CITY OF MILLS – PLANNING DEPT.

Staff Report — Midway Subdivision No. 2 (26-187)

CITY OF MILLS — PLANNING DEPARTMENT

Wyoming Classical Academy Phase II Development Plan

MASTER SITE PLAN

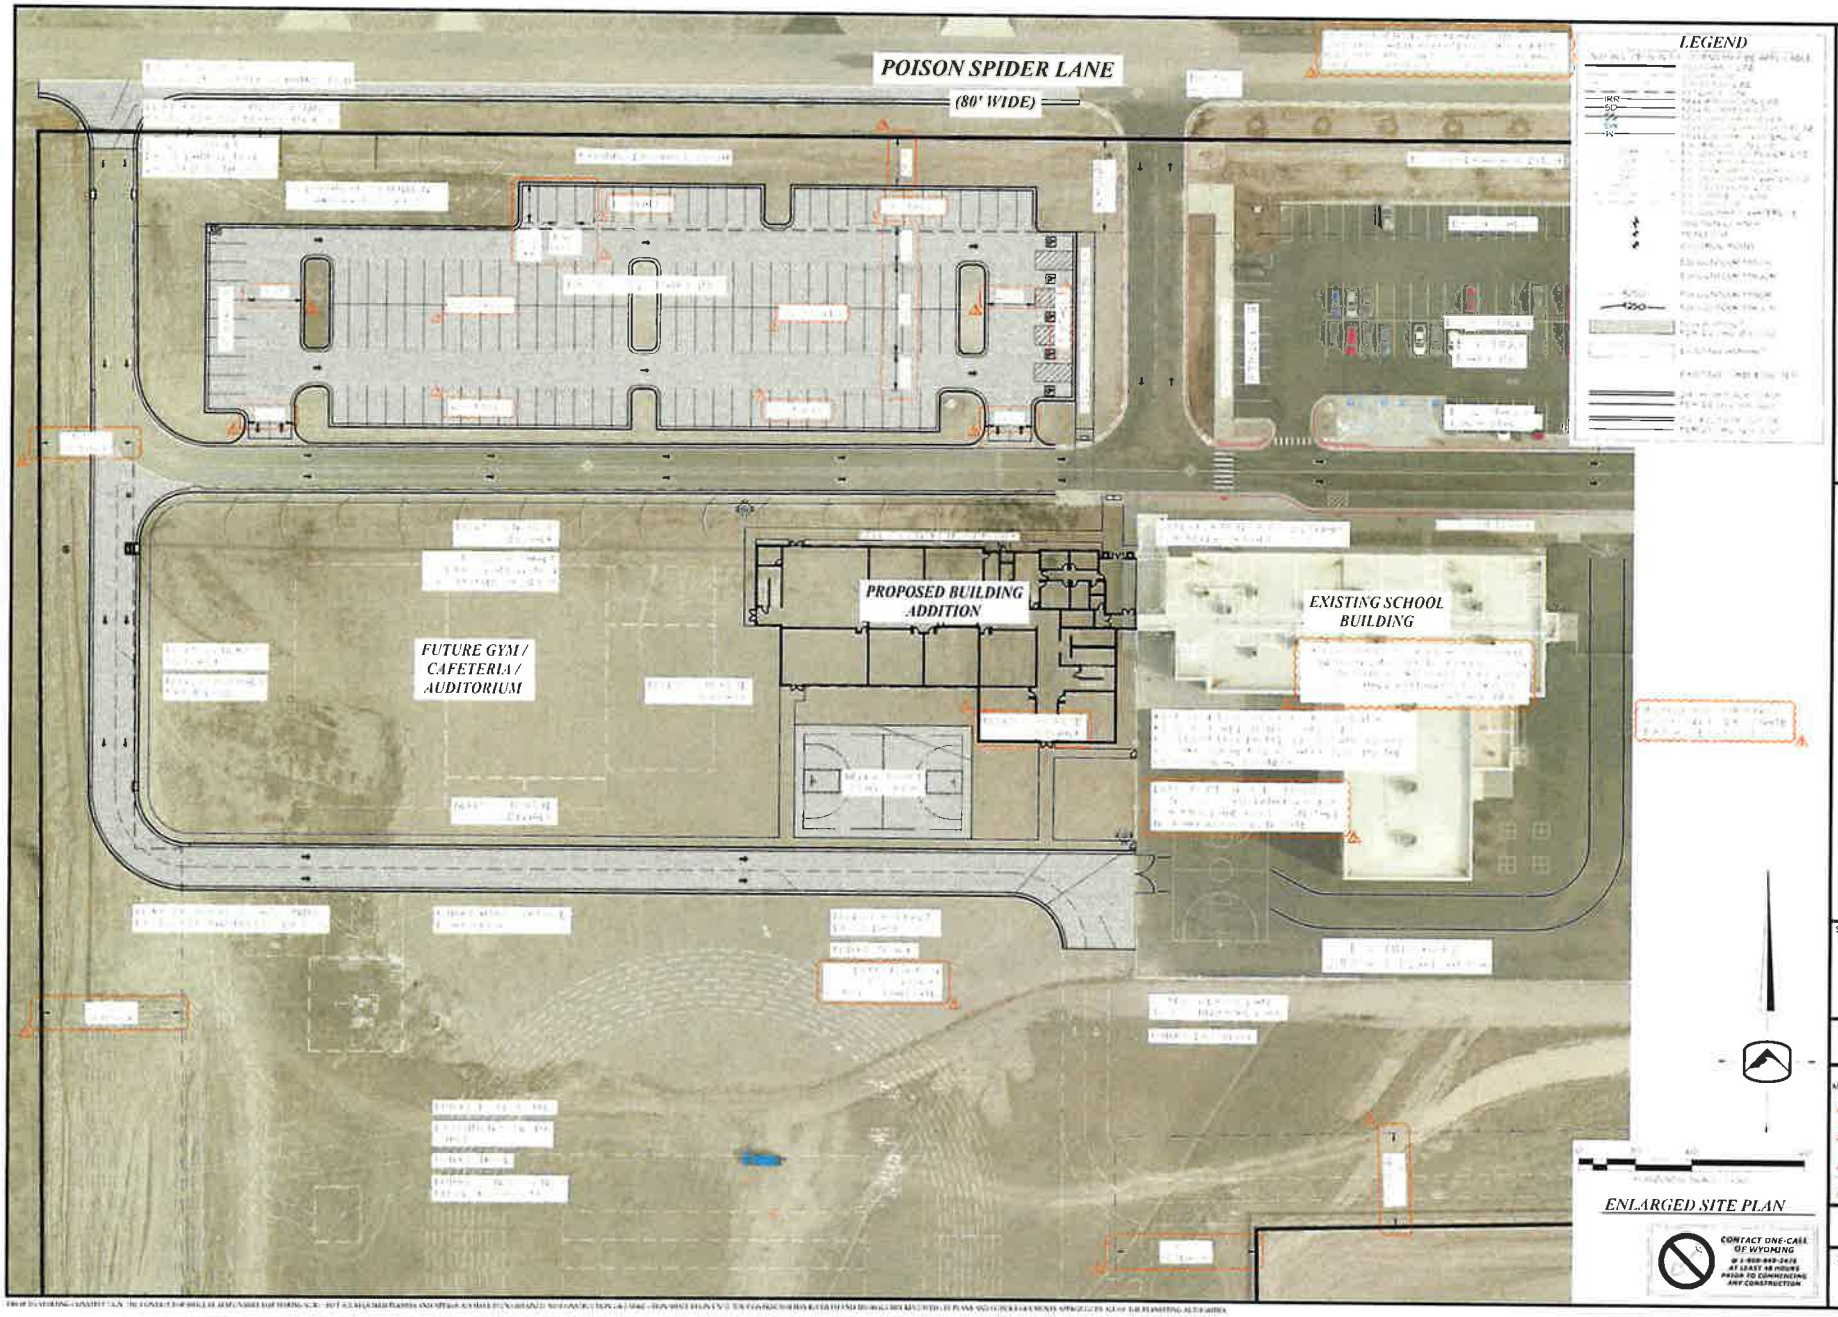
A school is a permitted use in the UA district, and the addition meets the UA setback, height, and lot coverage standards. Sheet C200 shows 20.52 acres, which meets the 20-acre UA minimum. The Applicant has explained that the replat follows site plan approval and the financing and land closing. Because the development occurs on singularly owned property, the timing of the replat goes to the Development Plan Agreement and is not a Commission condition.

TRAFFIC CIRCULATION PLAN

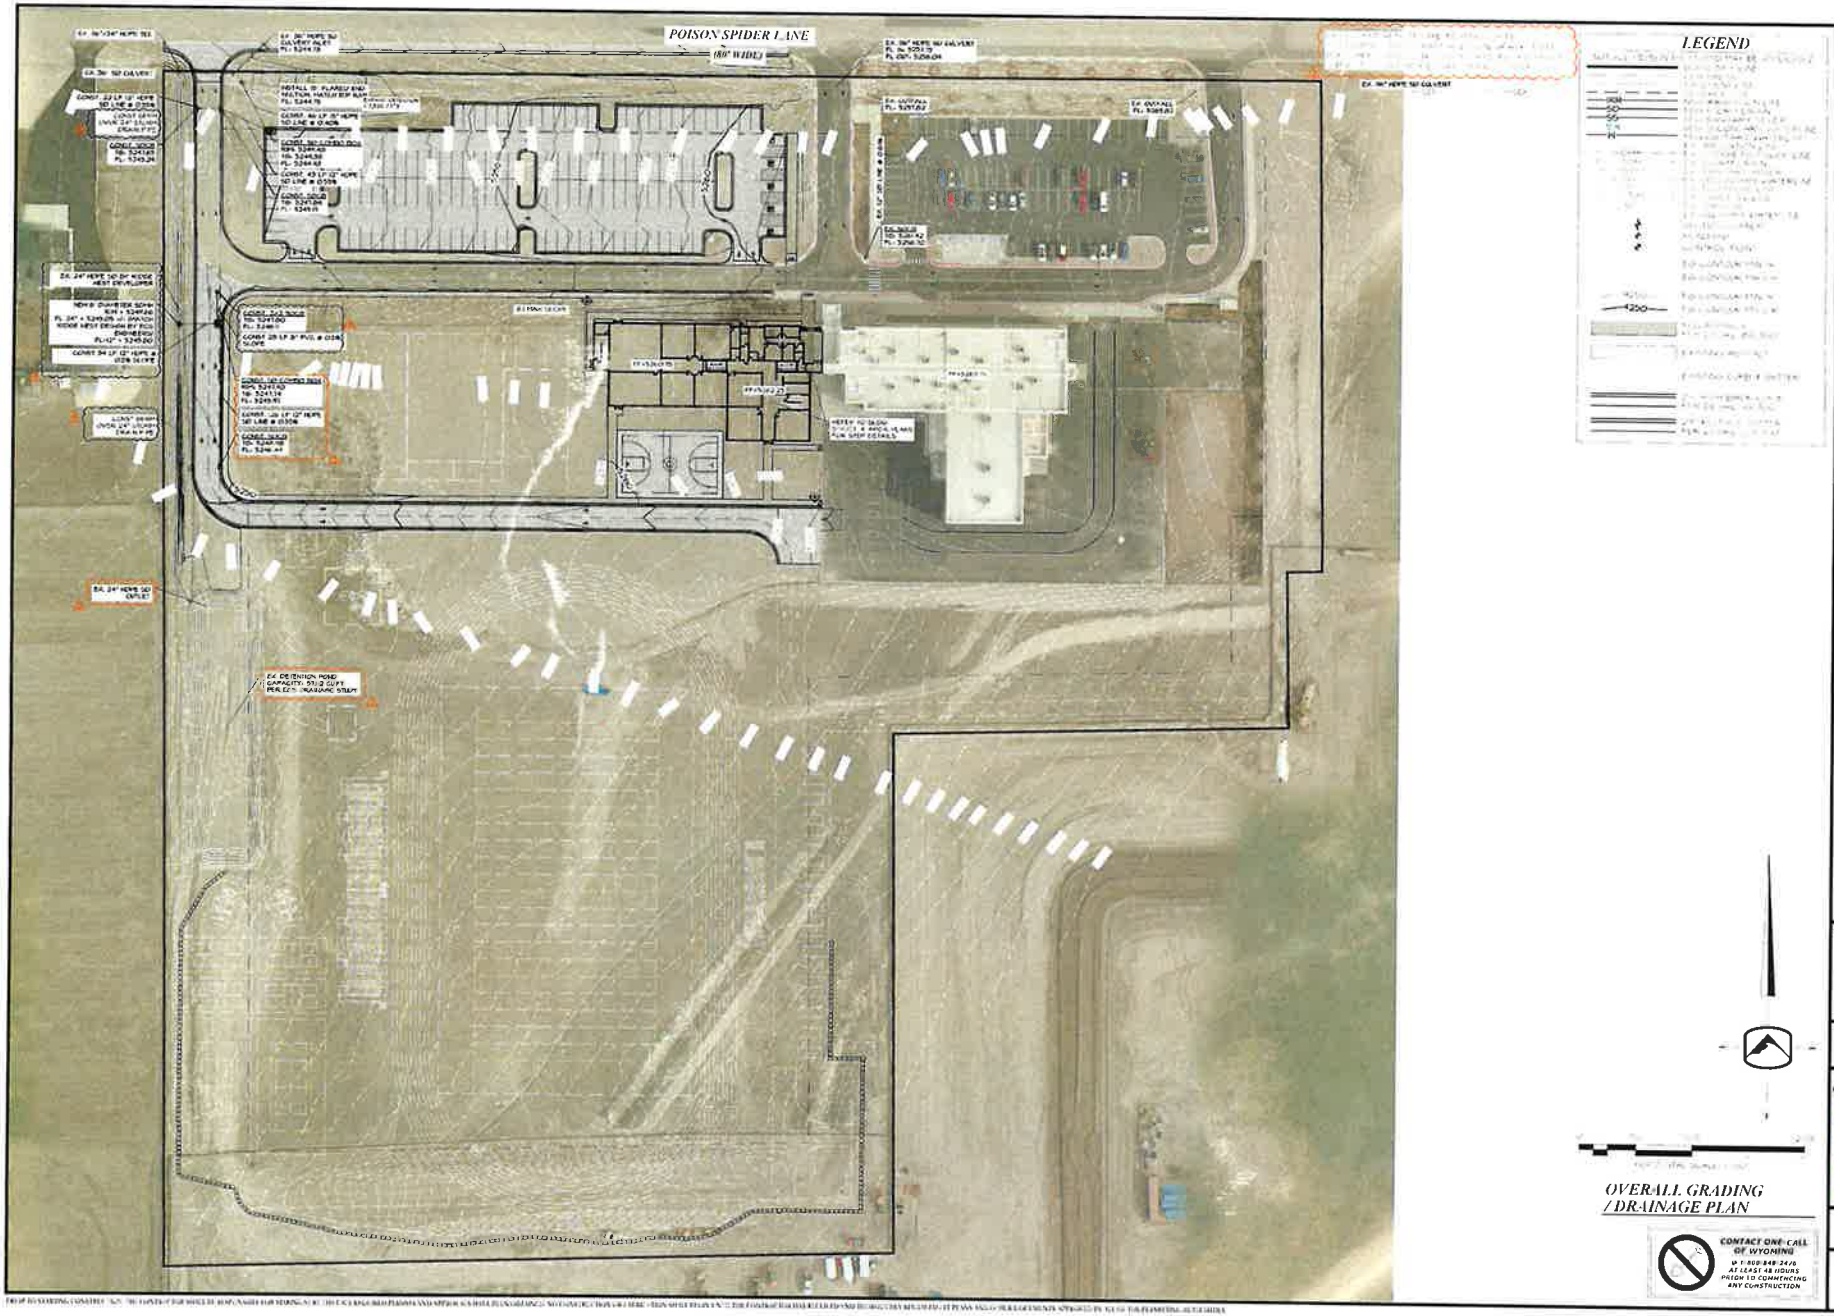
On site, the TIS finds about 2,100 ft. of stacking when the car line is double-stacked. Its VISSIM model at 610 students with a single dismissal produced a 95th-percentile queue of about 2,130 ft. The study expects staggered start and dismissal times, together with double-stacking, to keep the queue on site. The stacking lanes are shown on Sheet C202, and the central access is designated for parking-lot access.

23. Double-stacked car line: A signed commitment to use both stacking lanes at every arrival and dismissal, operated as shown on Sheet C202.
23 Response: The applicant would like to incorporate this into the development agreement agreement

- **Circulation:** a 26-ft. drive lane along the west side and a 24-ft. drive lane south of the addition. The south lane loops to the existing hard-surface play area, which serves as the fire lane. Stacking lanes for a double-stacked car line are shown on the Traffic Circulation Plan (C202).

1. **School traffic flow plan.** The school traffic flow plan shall be subject to the Development Plan Agreement. It covers car line operation, including the double-stacked car line at 550 students, and use of the central access for parking during pick-up and drop-off. The plan shall be established in conjunction with school population and developed as a joint effort among the Mills Police Department, Public Works, and school staff.
2. **Future phases.** This approval does not include the gymnasium/cafeteria/auditorium, track, football field, bleachers, concessions/restrooms, pickleball and tennis courts, playgrounds, trails, or retaining walls labeled "future." Each requires separate City approval. The Recreation Facility use is Review Process 3 in the UA district.

OVERALL GRADING DRAINAGE PLAN

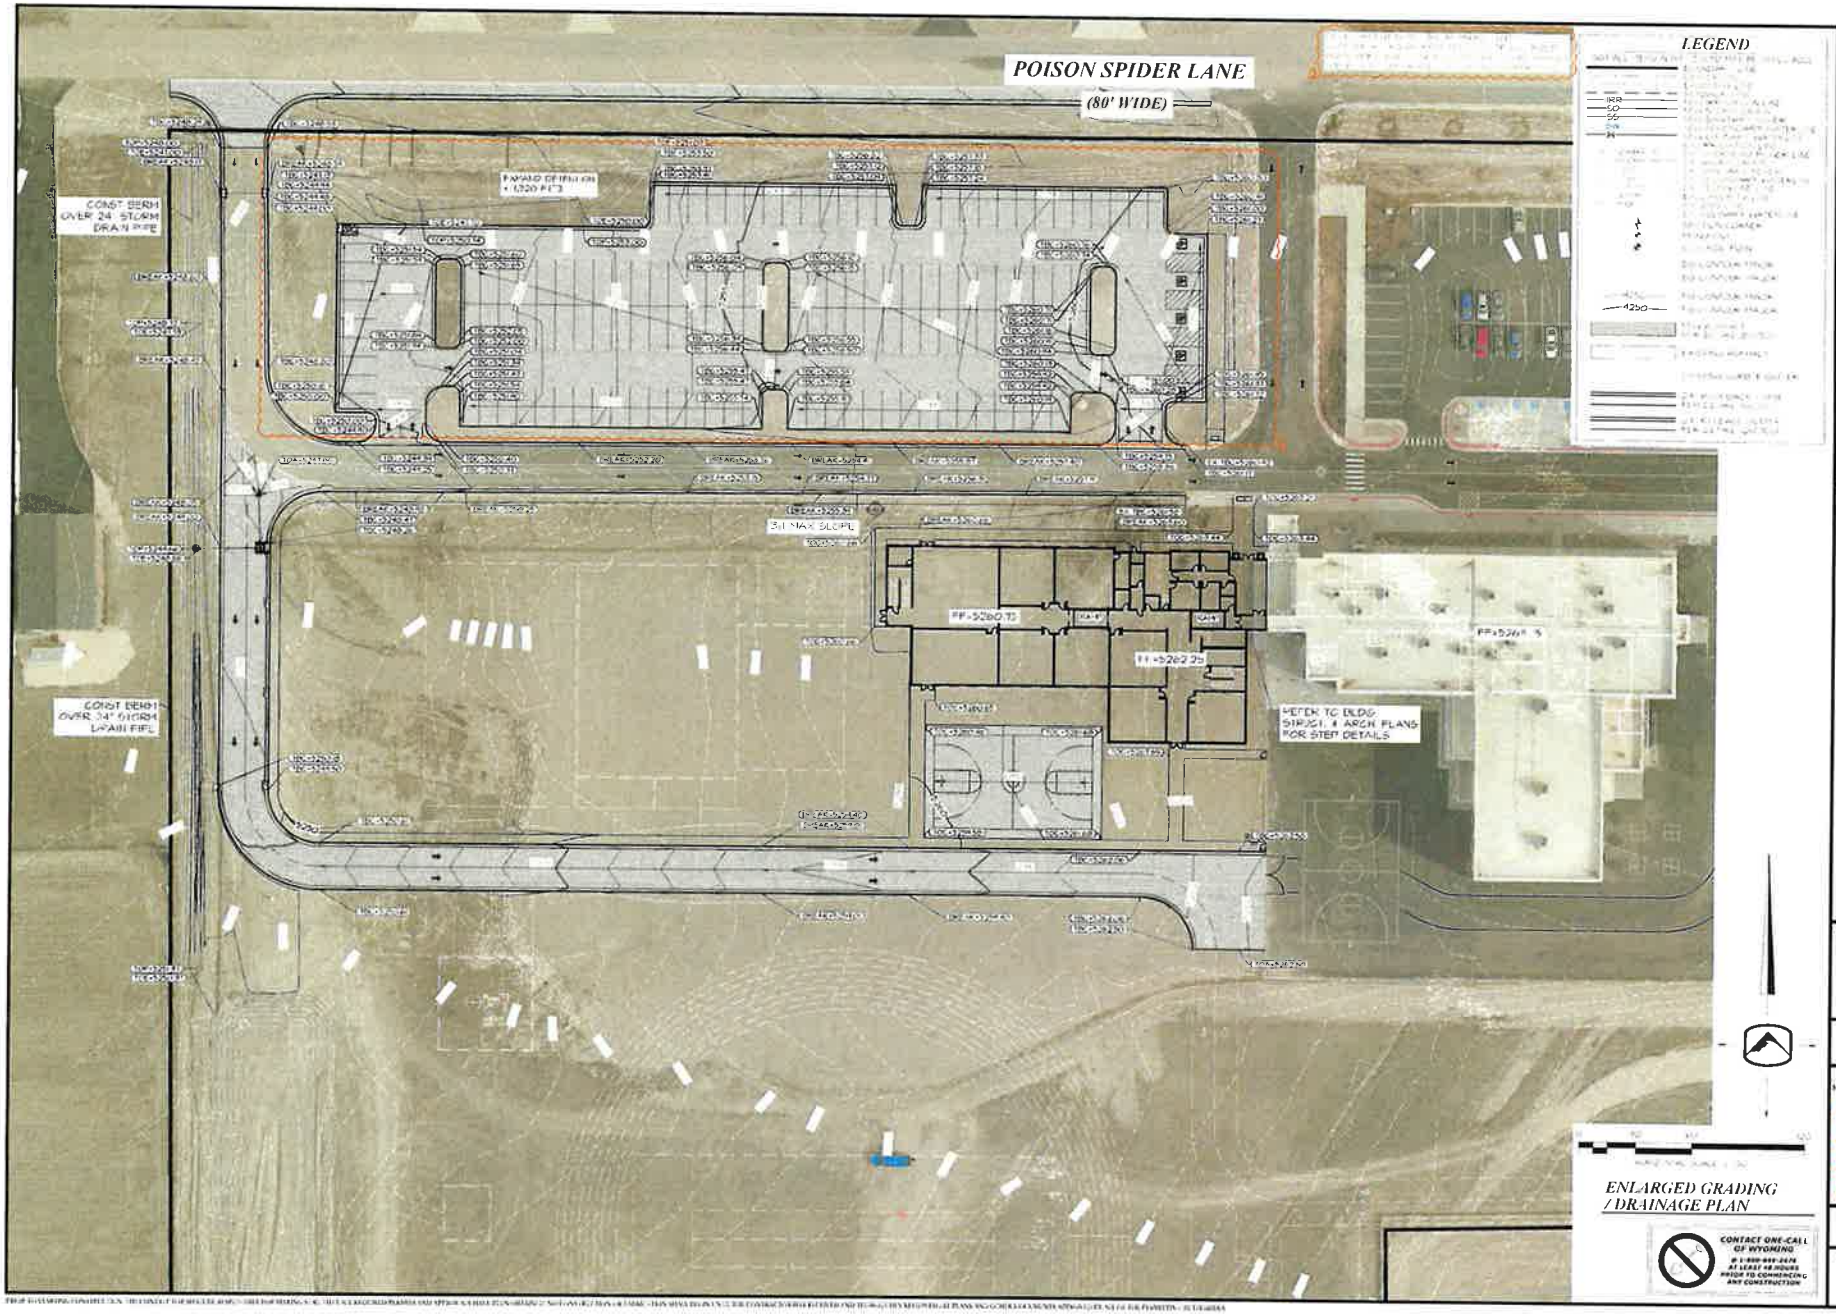
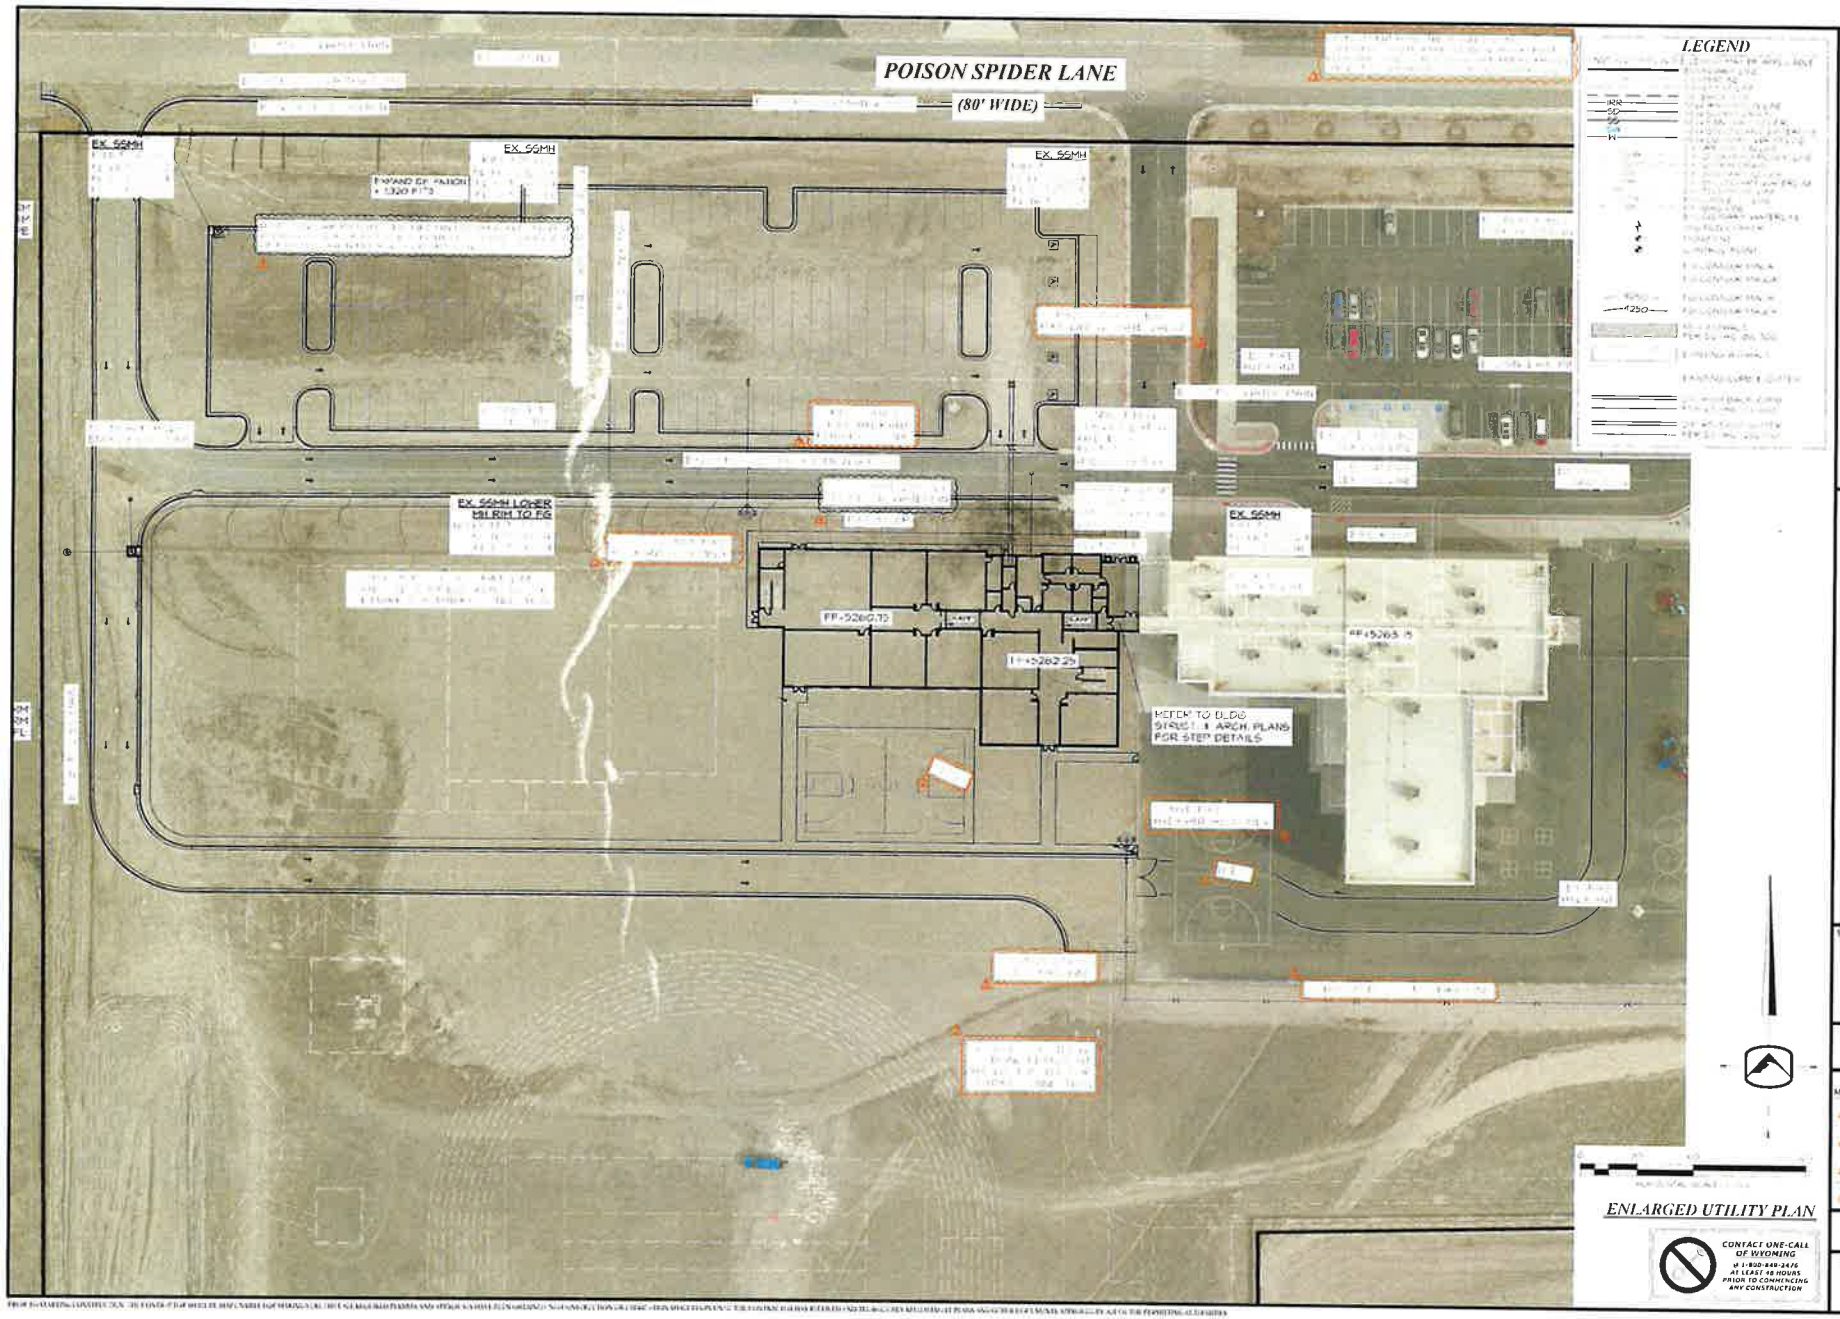
4. Drainage area to the ditch: An explanation of the change in area draining to the ditch from 18.62 to 9.67 acres, supported by the map in item 6.
4 Response: The plan for the entire area has been revised and updated with the revised report and plans.

6. Indexed drainage and grading map: One exhibit that ties the drawings to the calculations: each basin labeled and keyed to the study with its acreage and runoff coefficient, flow arrows, design points, existing and proposed grades, the ditch, culvert, curb cuts, pond, and every discharge point, with an index or legend.
6 Response: See attachments to the report.

The City Engineer has accepted the drainage material in the plan set, using the detailed elevations as the basis for approval. The City Engineer also cited the additional detention along Poison Spider Lane as a factor in reducing off-site impact through staged storage. Staff finds Items 1–6 resolved and the requirements of §10.40(7)(e) and §10.40(2)(g) met.
